DEPARTMENT OF NATURAL RESOURCES
DIVISION OF OIL, GAS AND MINING

RE: Site Inspection, U. S. Energy Corp., Velvet Mine, M/037/040, San Juan County, Utah

Date of Inspection: May 29, 2003
Time of Inspection: 10:30 a.m. to 1:30 p.m.
Conditions: Mostly clear, 80's
Participants: Ted McDougall (BLM), Fred Craft (U. S. Energy), Jim Butt (contractor for U. S. Energy), and Paul Baker (DOGM)

Photo 7. One of the vent shafts. This photo clearly shows the plate attached to the casing and to the fan.

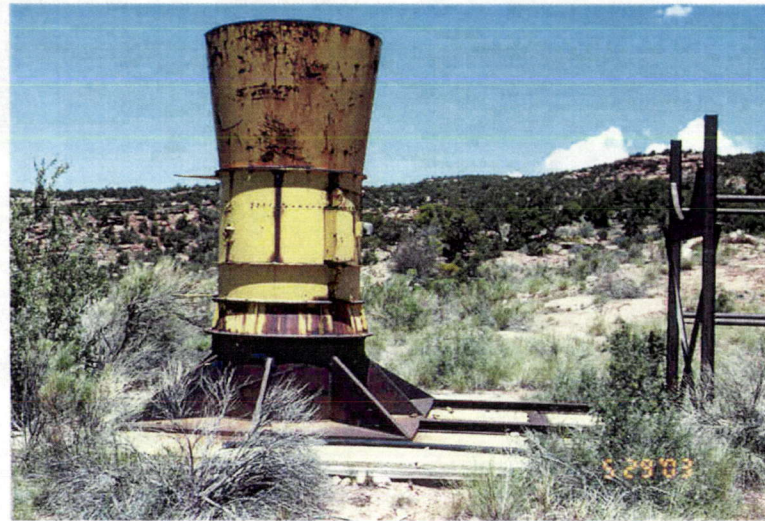
There are three ventilation shafts, and one of these has a headframe and hoist house (Photos 7 and 8). At the ventilation shafts, the top of the casing was placed in such a way that the casing extends about one or two feet above the ground surface. There is a large metal plate on the surface attached to and surrounding the casing (Photo 7). The purpose of the metal plate was to have a more secure base to which the casing could be attached.

The mine plan says the vent holes will be sealed by welding a steel plate to the casing and covering this with fill/soil. During this inspection, the operator proposed to cap the vent holes with reinforced concrete. The plates around the casings would be left in place to provide stability, and the concrete would come over the sides of the casings down to the plates. The concrete would then be covered with soil and the area revegetated. Mr. McDougall and I agreed this would be a much better way to seal these shafts than the approved method, and I felt it should be adequate.
